CIMARRON HILLS SOUTHEAST MIXED USE FILING NO. 1

FINAL DRAINAGE REPORT

Project No. 24.1382.003

PCD File SF2420

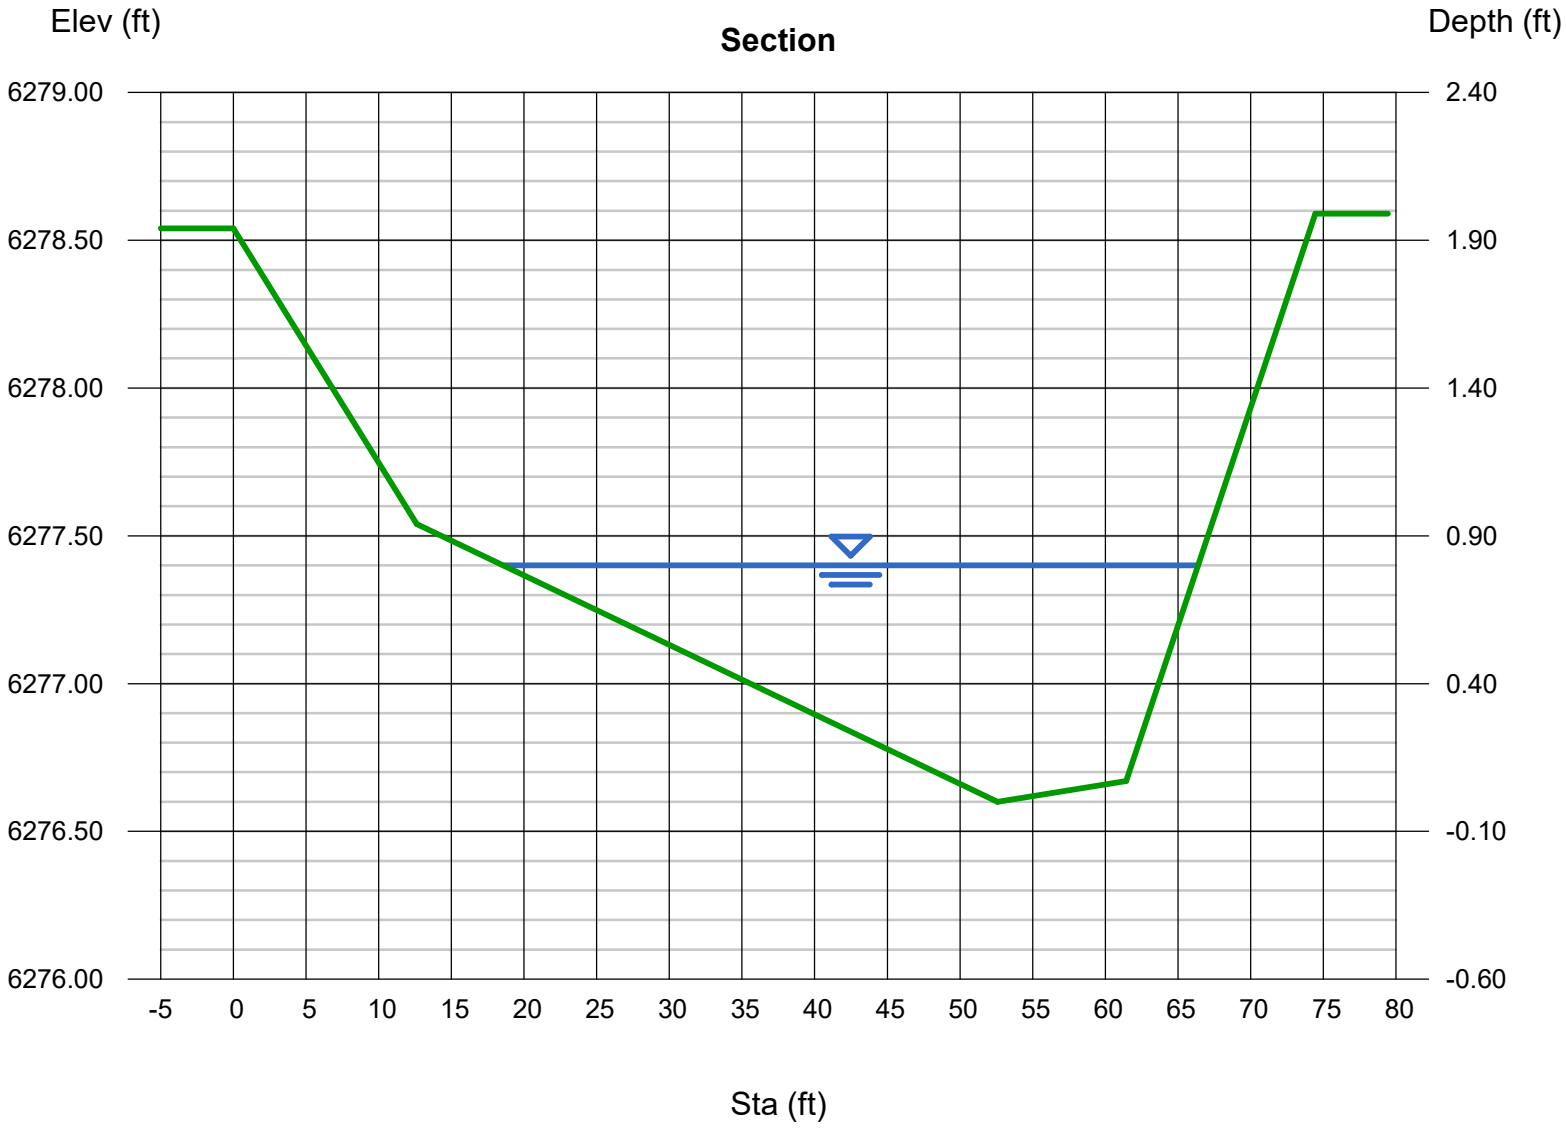
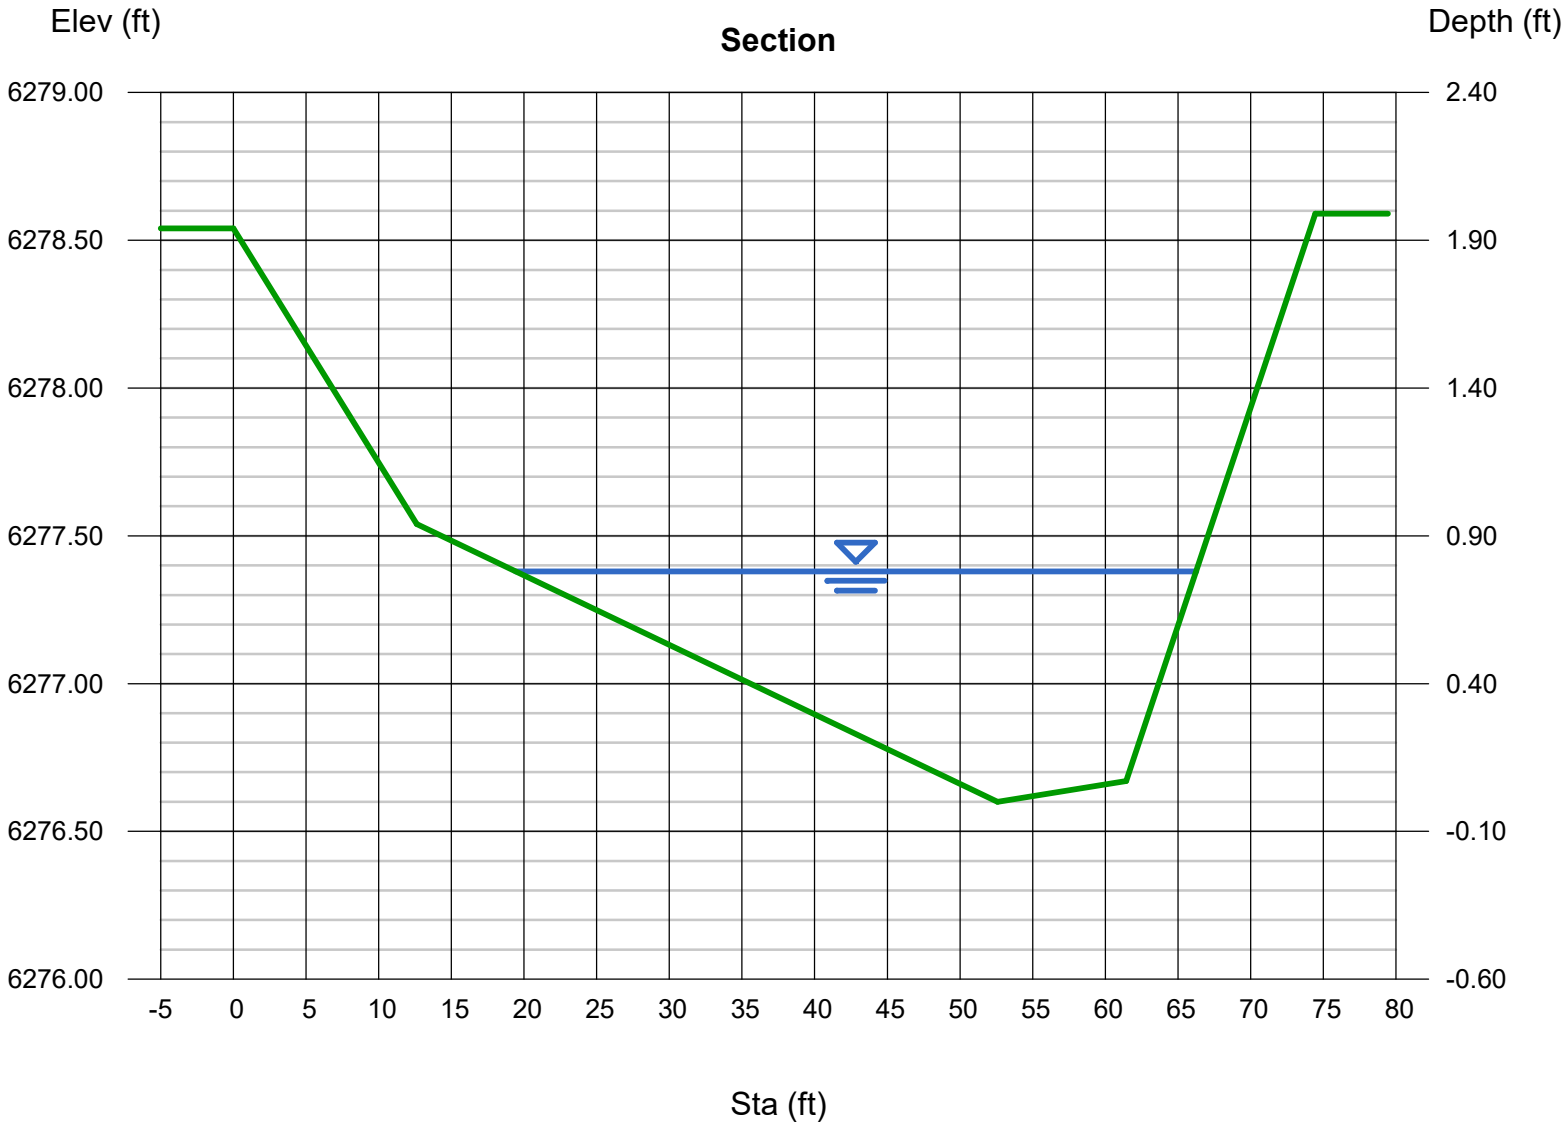
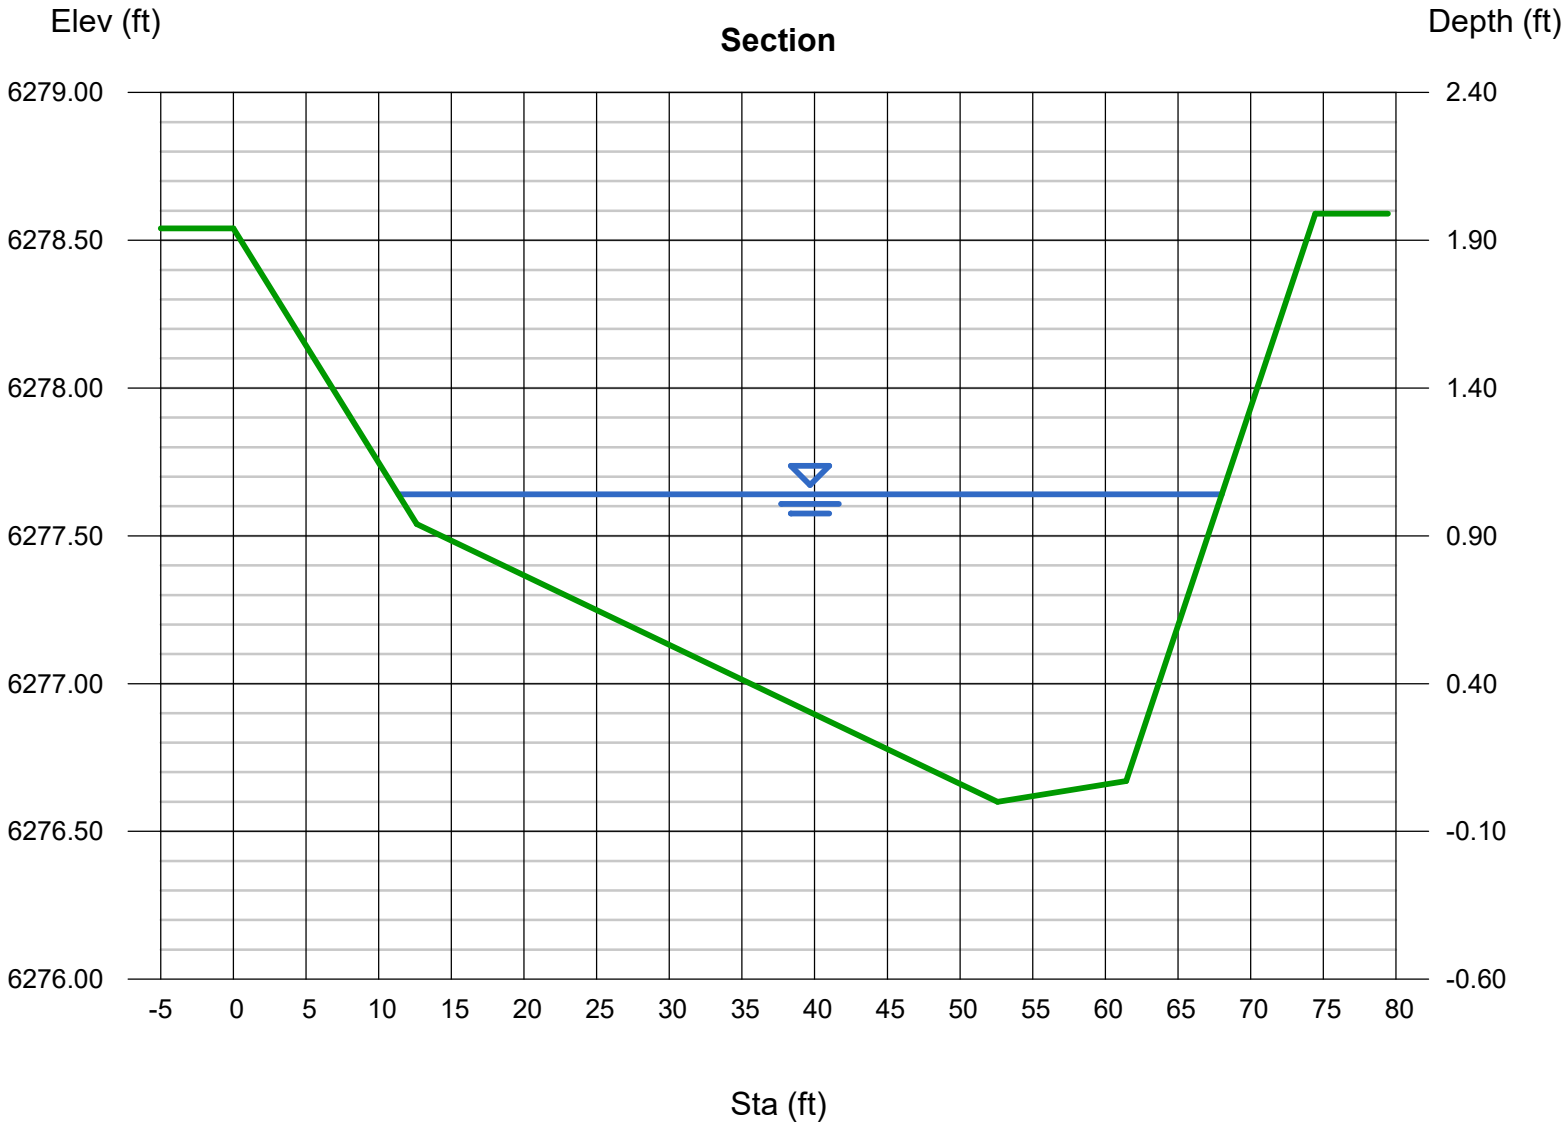
Please include Peterson Culvert sheet, which had been included in last submittal, back in.
